# Access Compliance Report

## Public Rights-of-Way

### (Curb Ramps)

Intersection ID: 7965	Main Street: BROOKWAY_DR	Cross Street: S_RAMSEY_ST	Location: S
ADA ID: 0287D9B2A0CF	Ramp Type: Perp	Initial Pass/Fail: Fail	Overall Compliance: No
Severity Score: 21.25			
Codes/Mitigation Info/Possible Solution		Field Measurements/Component Compliance

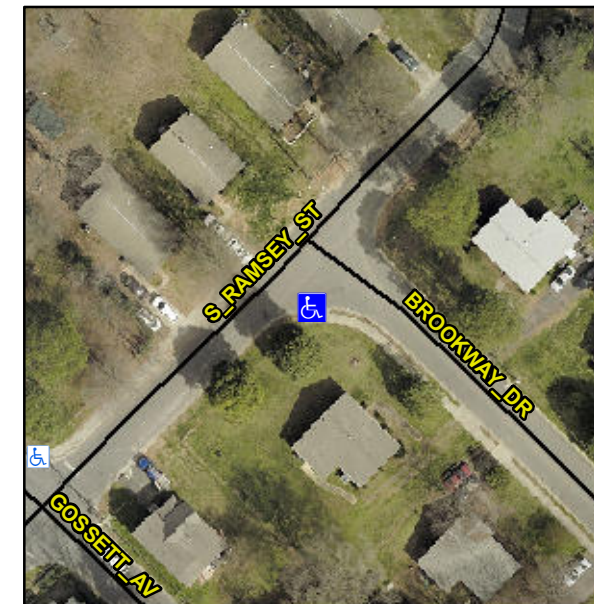
**Remove & Replace Entire Ramp.**

**Not Found, R304.5.1, R304.2.2**

Compliance	Description	Data	Compliance	Description	Data
N/A	Ramp Length (in)	53.5	No	Ramp Slope (%)	8.4
No	Ramp Width (in)	47.0	Yes	Ramp XSlope (%)	0.8
N/A	Flare Type LT	N/A	N/A	Flare Type RT	N/A
N/A	Flare Slope LT (%)	N/A	N/A	Flare Slope RT (%)	N/A
N/A	Flare Traversable LT?	N/A	N/A	Flare Traversable RT?	N/A
N/A	Landing Length (in)	N/A	N/A	DWS Provided?	N/A
N/A	Landing Width (in)	N/A	N/A	DWS Contrast?	N/A
N/A	Landing Slope (%)	N/A	N/A	DWS Length (in)	N/A
N/A	Landing X Slope (%)	N/A	N/A	DWS Full Width?	N/A
N/A	Landing Curb? (Y/N)	N/A	N/A	DWS Offset (in)	N/A
N/A	Shared Landing?	N/A			
N/A	Gutter Ponding?	N/A	N/A	Gutter Slope (%)	N/A
N/A	Gutter Lip Ht (in)	N/A	N/A	Gutter X Slope (%)	N/A
N/A	Painted X Walk1?	No	N/A	Painted X Walk2?	N/A
	X Walk 1 Direction	To NE		X Walk 2 Direction	N/A
N/A	X Walk 1 Width (in)	N/A	N/A	X Walk 2 Width (in)	N/A
	X Walk 1 Slope (%)	2.9		X Walk 2 Slope (%)	N/A
	X Walk 1 X Slope (%)	0.6		X Walk 2 X Slope (%)	N/A
